**As-Built Baseline Monitoring Report**

**Bucky's Branch Mitigation Project**

RE: Bucky's Branch Mitigation Site: As-Built Baseline Monitoring Report (NCDMS ID 100109)

Listed below are comments provided by DMS on June 4, 2020 regarding the Bucky's Branch Mitigation Site Draft As-Built Monitoring Report and RES' responses.

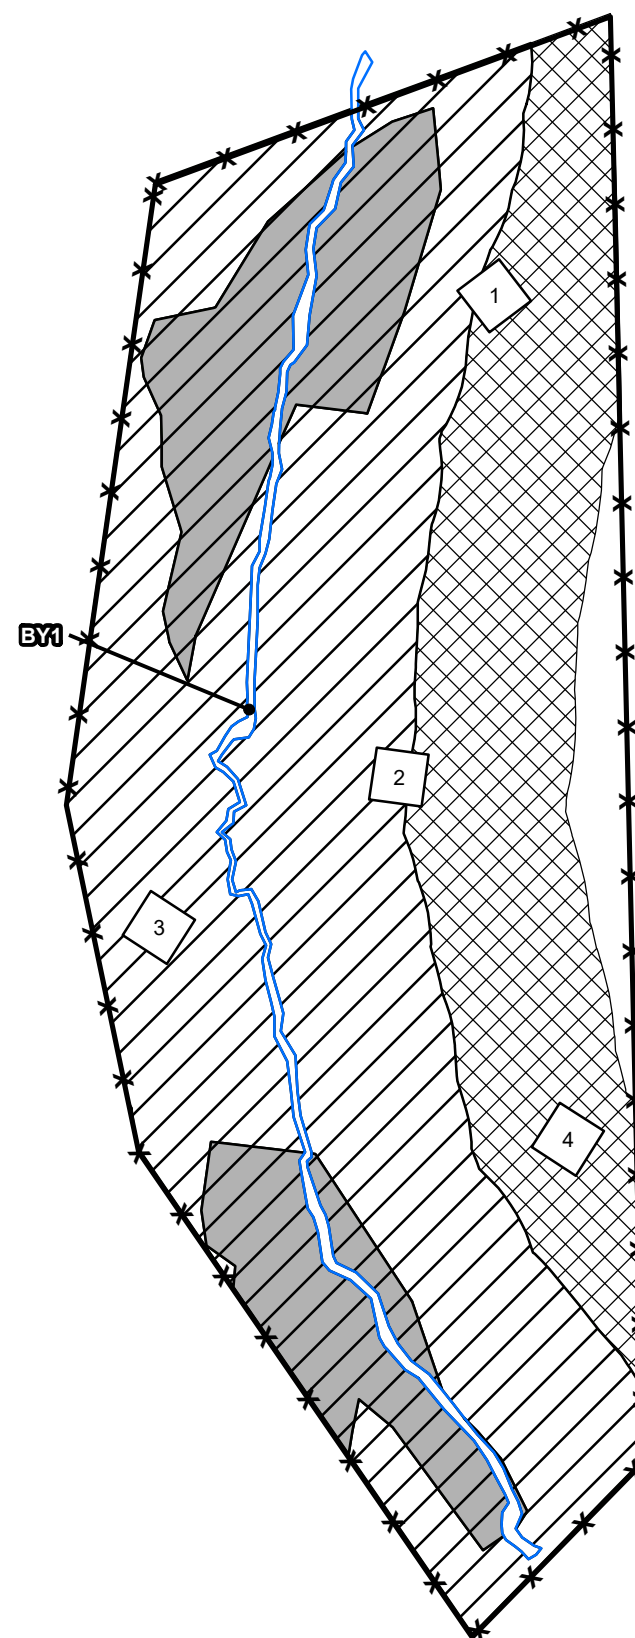
**Figure 3** – Any fencing installed at the site should be shown on the As-built Map.

[The As-Built map has been updated to show fencing.](#)
